Abel Ecology

Document No: 1472-LET-145

Response to exhibition feedback

Figure 1. Extract of Figure 12 from SEPP59 Stage 3

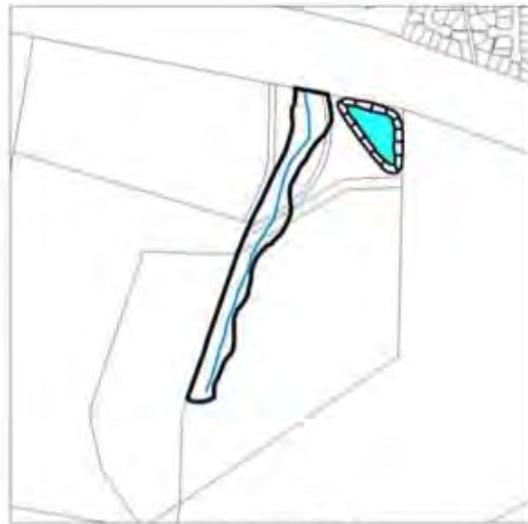
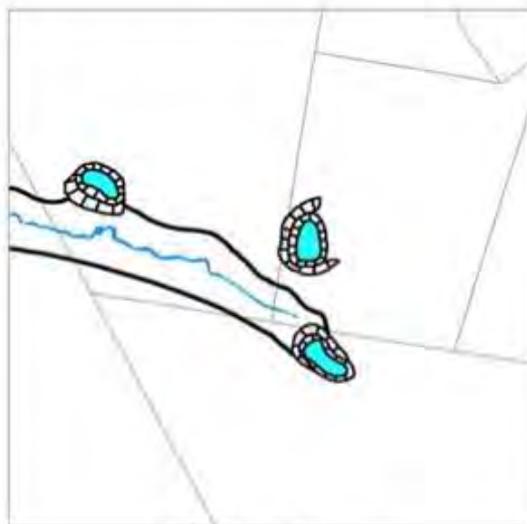
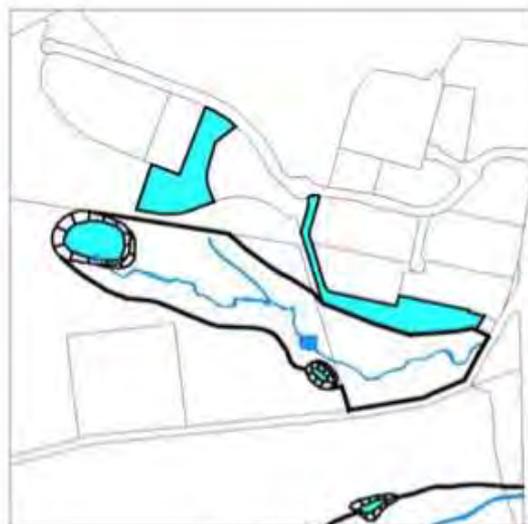
"The Director General's Requirements issued for SSD-6236 require an assessment of the development against State Environmental Planning Policy (Western Sydney Employment Area) 2009. Clause 19 (2) of this SEPP states "in determining a development application that relates to any land to which an existing precinct plan applies, the consent authority is to take the existing precinct plan into consideration". Clause 19(3)(b) of the SEPP lists the Eastern Creek Precinct Plan (stage 3) as an existing precinct plan.

SEPP 59 – Eastern Creek Precinct Plan (Stage 3) includes the following controls 5.6.1 (e), 8.3.5 (b), 8.4.3 (d) which relate to the riparian corridor along Ropes Creek Tributary:

It is assumed the riparian corridor is defined as the polygon displayed in Figure 12 (see below) and Figure 17 page 8-8 of SEPP59 (dated 14 December 2005). No buildings or laydown pad is proposed within this riparian corridor. Parts of the batters for Laydown Area No.5 and parts of the basin edge for the bio-retention basin overlap the riparian corridor. Figure 12 indicates basin edges are acceptable along riparian corridor boundaries

Vegetation is proposed along the batters which will function as landscaped open space and the vegetation will be tolerant of occasional flooding.

It is noted part of the batter for Laydown Pad No.5 overlaps the eastern portion of the riparian corridor boundary. It is a variation to the control (page 11-17 SEPP 59 –Eastern Creek Precinct Plan (Stage 3) Dated: 14 December 2005), which states:

Figure 7. Close up of vegetation adjacent to Ropes Creek Tributary and adjoining areas.

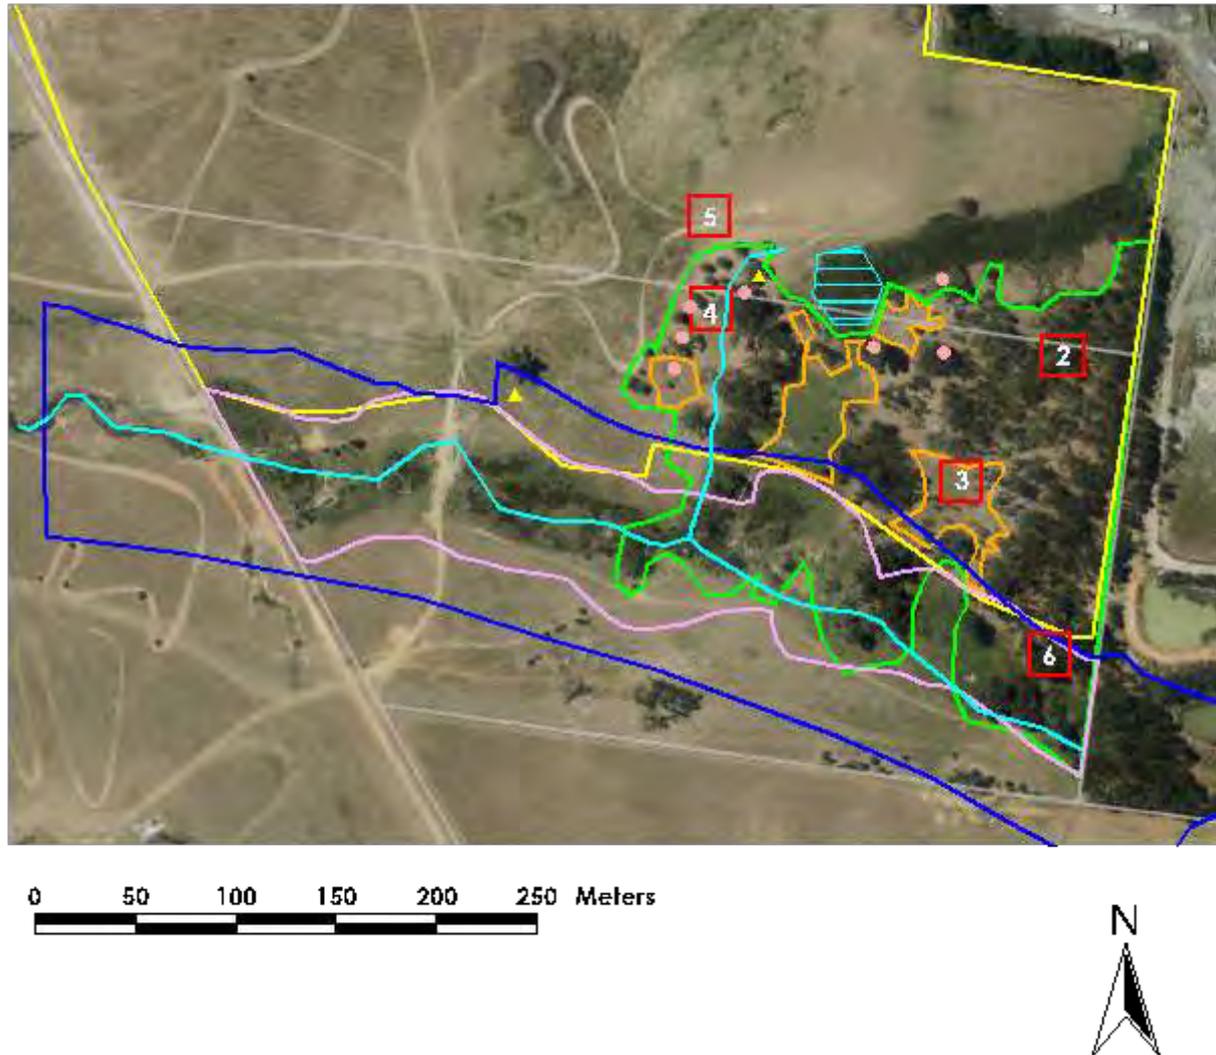
“OEH’s previous comments also raised the issue that the report should include data from the quadrats. It is noted that the quadrat data has now been provided and figures in the FFAR display the location of the quadrats, however the quadrats should be numbered in these figures so that the data can be related back to its location.”

The figures displaying the locations of the quadrats have been amended and are attached to this document as an amendment (Attachment A).
